# Product Change Notification

PCN20-23-JS Series Slide Switch Base Material Improvement

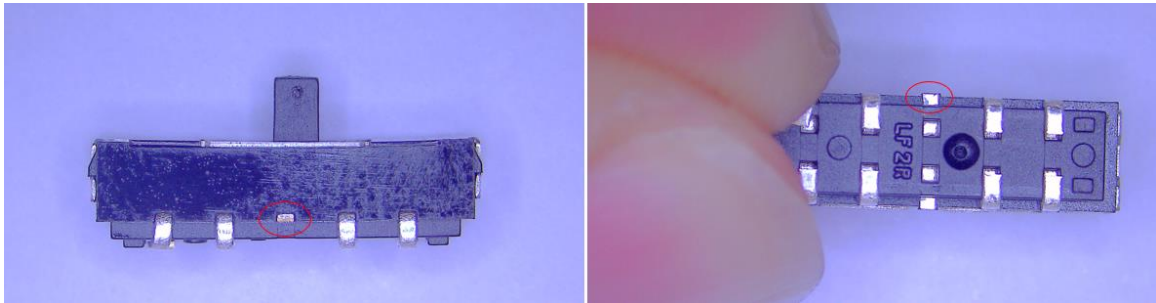
- 3.1 The base material plastic is changing from PA46 to PPA in order to leverage the lower water absorption of PPA as compared with PA46.
- 3.2 There is an associated cosmetic change in switch appearance as seen in the pictures below showing a trimmed off additional terminal in the middle of the switch base. This terminal is trimmed off such that it extends no more than 0.3mm outward from the switch base after trimming.
